APPLICATION NO.	FILING DATE	FIRST NAMED INVENTOR	ATTORNEY DOCKET NO.	CONFIRMATION NO.
10/076,025	02/13/2002	Andre Larsen	NN-6259.200 US	7371
26137	7590	11/28/2003	EXAMINER	
PATENT DEPARTMENT SKADDEN, ARPS, SLATE, MEAGHER & FLOM LLP FOUR TIMES SQUARE NEW YORK, NY 10036			MENDEZ, MANUEL A	
		ART UNIT	PAPER NUMBER	
		3763		
DATE MAILED: 11/28/2003

<b>Office Action Summary</b>	Application No.	Applicant(s)
	10/076,025	LARSEN ET AL.
	Examiner Manuel Mendez	Art Unit 3763. . w.

## DETAILED ACTION

**FIG. 2**

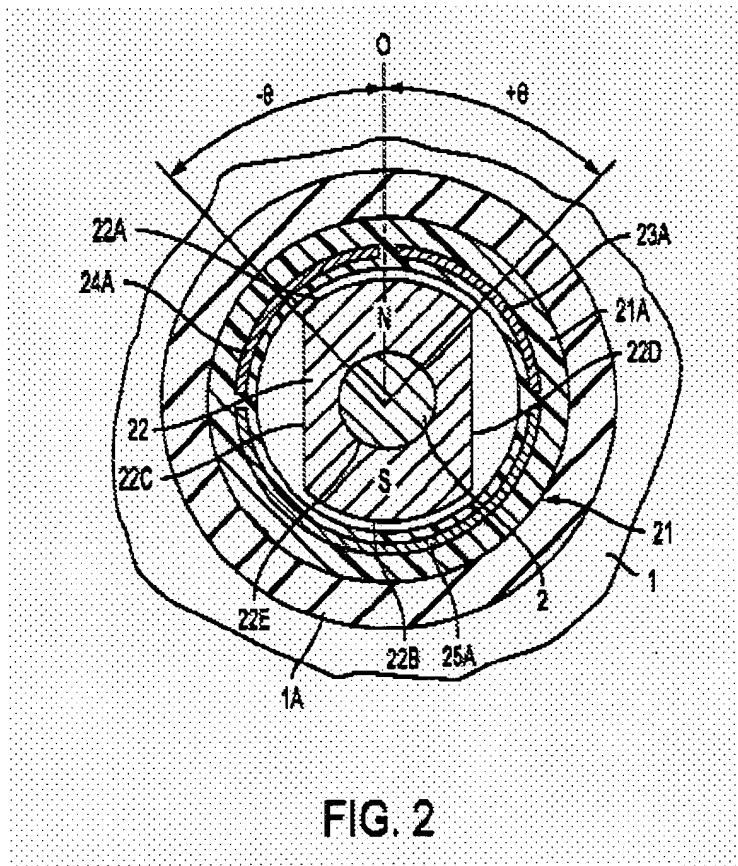
Claims 10-15 are rejected under 35 U.S.C. 103(a) as being unpatentable over **Groshong, et al., Gray, and/or Barton, et al.** in view of **Kogure, et al.** Neither **Groshong, et al., Gray, nor Barton, et al.**, disclose a magnet having the shape of a magnet ring. However, designing a magnet with the shape of a ring is conventional as evidenced by the teachings of **Kogure, et al.**

In figure 2, the Kogure, et al. Patent shows a magnet (22) having a ring shape. Based on the conventionality of ring-shaped magnets, for a person of ordinary skill in the art, such use in any infusion system would have been considered an obvious design alternative.
